DOMINION NUCLEAR NORTH ANNA, LLC
NORTH ANNA EARLY SITE PERMIT APPLICATION
FINAL SAFETY EVALUATION REPORT REVIEW ITEMS AND REVISION 5 TO THE
NORTH ANNA ESP APPLICATION

Final Safety Evaluation Report Review Items

**Description of Changes in Revision 5
North Anna Early Site Permit Application**

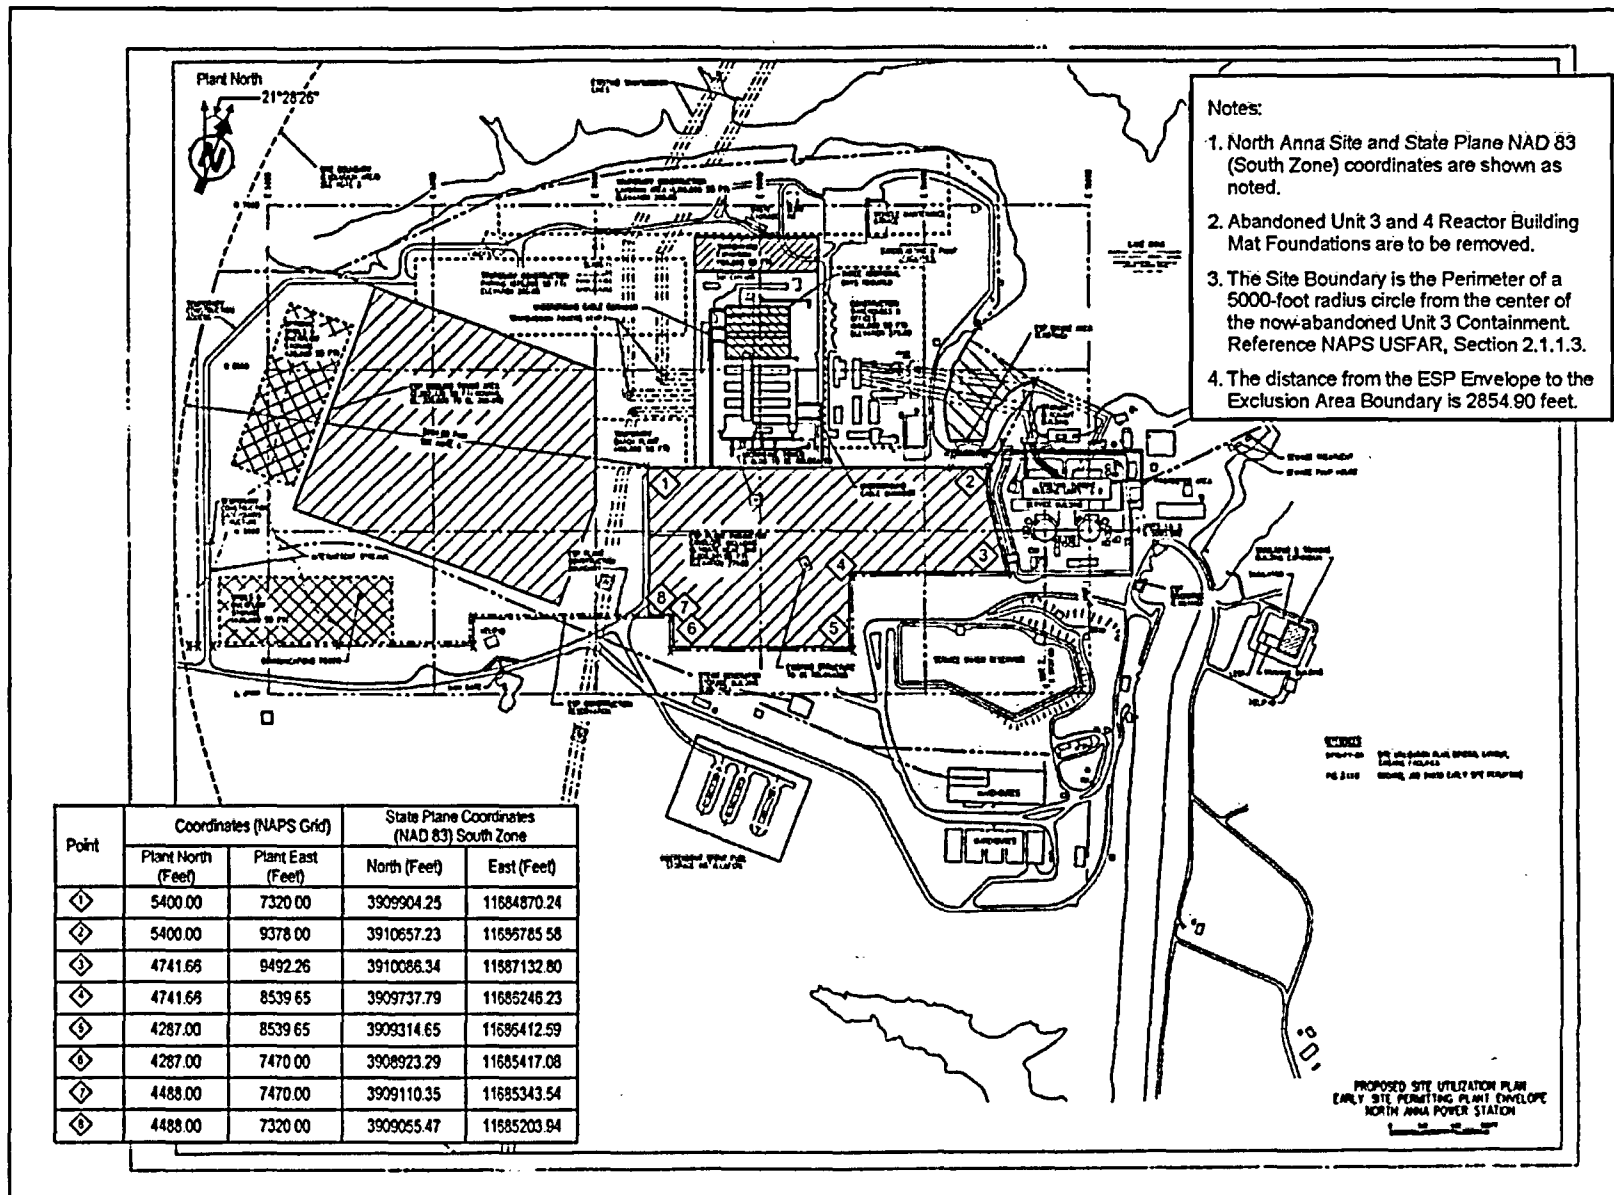
Correction of Coordinates for ESP Site Footprint

Coordinates for the ESP site footprint were submitted to the NRC in response to Draft Safety Evaluation Report (DSER) Open Item 2.4-1 (Dominion Letter 05-785B dated March 3, 2005).

As discussed in a July 5, 2005 conference call with NRC Staff, upon further review, it has been determined that the coordinates identified in Figure 1 of the DSER Open Item 2.4-1 response contained errors.

A corrected version of Figure 1 is provided on the next page.

None. Figure 1 on the next page is not included in the North Anna ESP Application.

Figure 2.5-55A

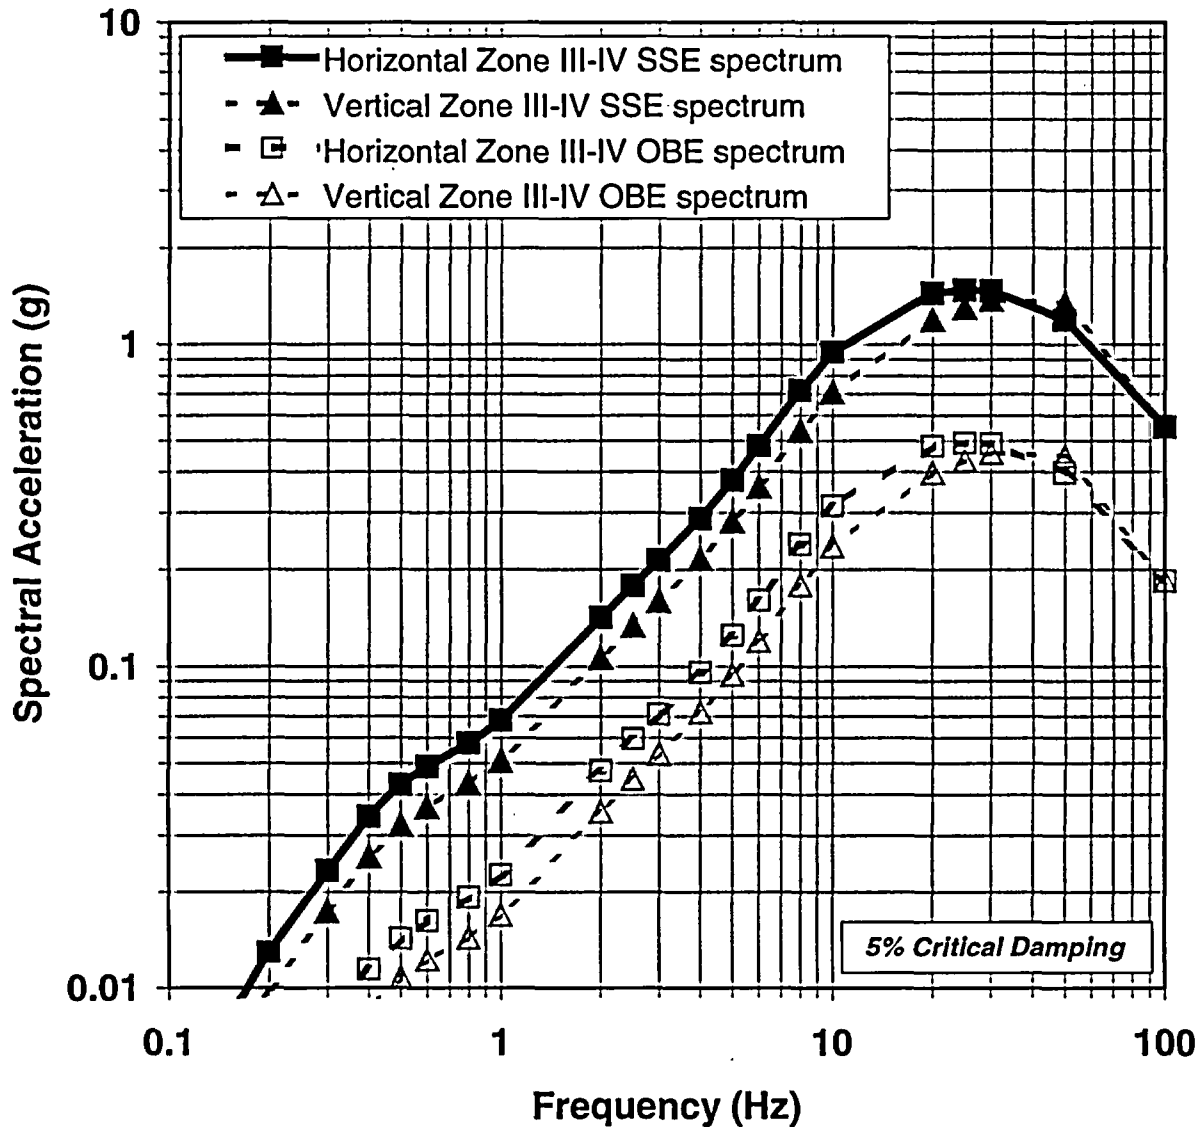
Incorrect Version of SSAR Figure 2.5-55A

Revision 4 of the North Anna ESP Application included an incorrect version of SSAR Figure 2.5-55A. (A duplicate copy of SSAR Figure 2.5-55 was inadvertently included as SSAR Figure 2.5-55A.)

The correct version of SSAR Figure 2.5-55A has been incorporated in Revision 5 of the ESP Application.

In Revision 5 of the ESP Application, SSAR Figure 2.5-55A has been replaced with the correct version shown on the next page.

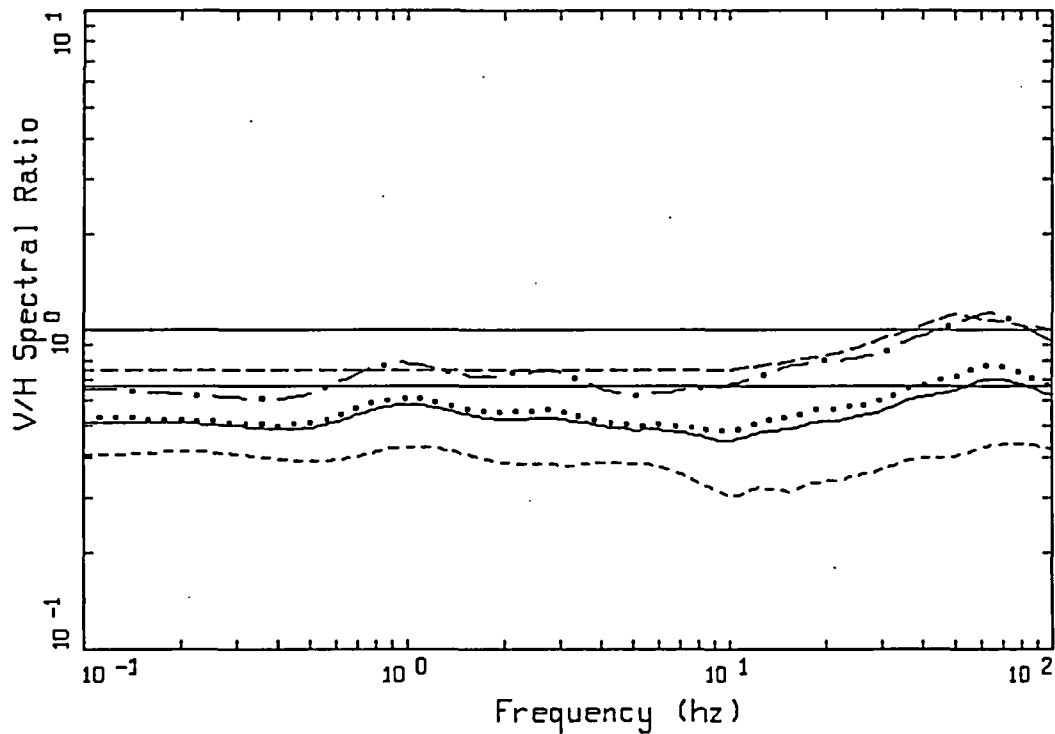
The statistical results of the V/H spectral ratios for the 0.5% damping level are shown in Figure 2. For comparison purposes, the V/H ratio for the 0.2g<PGA<0.5g bin from NUREG/CR-6728, which was used in SSAR Table 2.5-27A, is shown in Figure 2.

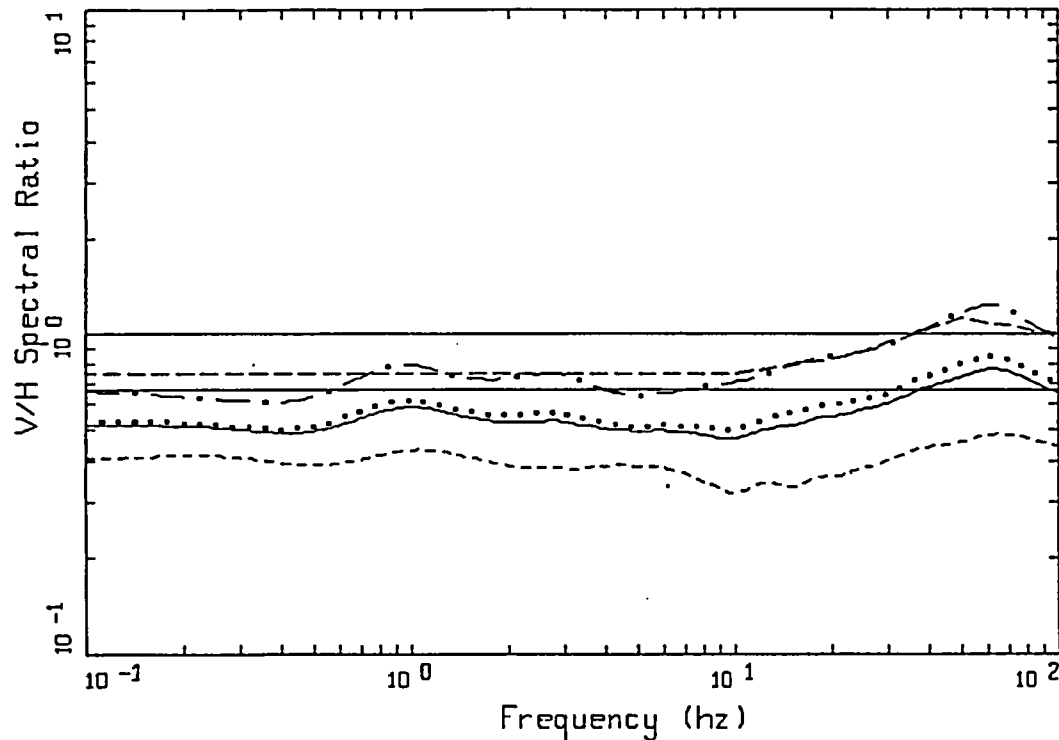
The 16th, 50th, and 84th percentiles and mean V/H ratios are shown in Figure 4 for the 2.0% damping case and listed in Table 2. For comparison, the V/H ratios from NUREG/CR-6728 for the $0.2g < PGA < 0.5g$ case, which was used for SSAR Table 2.5-27A, are also shown in Figure 4 and listed in Table 2. On average, the mean V/H ratios from the site-specific analysis are approximately 30% lower (ranging from 18-35% lower) over the complete frequency range of 100 Hz to 0.1 Hz than the V/H ratios used in SSAR Table 2.5-27A. At the 84th percentile, the site-specific V/H ratio values are on average 8% lower (ranging from 19% lower to 5% higher) over the entire frequency range than the SSAR Table 2.5-27A V/H ratio values.

The site-specific analysis included the deaggregation information from the high frequency (i.e., 5-10 Hz) controlling earthquake only. If a more detailed analysis were performed, the deaggregation events from the low-frequency (i.e., 1-2.5 Hz) deaggregation would be included. In addition, the 5-10 Hz deaggregation events for distances greater than 75 km were included in the 75 km case. The above factors, if implemented, would result in smaller V/H ratios within the low-frequency range than those currently shown in Figure 4.

The results of the site-specific analysis confirm the appropriateness of the V/H ratios listed in Table 2.5-27A. Compared with the Table 2.5-27A values, the mean V/H ratios from the site-specific analysis are, on average, approximately 30% lower (ranging from 18-35% lower) over the complete frequency range of 100 Hz to 0.1 Hz. At the 84th percentile, the site-specific V/H ratio values are on average 8% lower (ranging from 19% lower to 5% higher) over the entire frequency range than the Table 2.5-27A V/H ratio values.
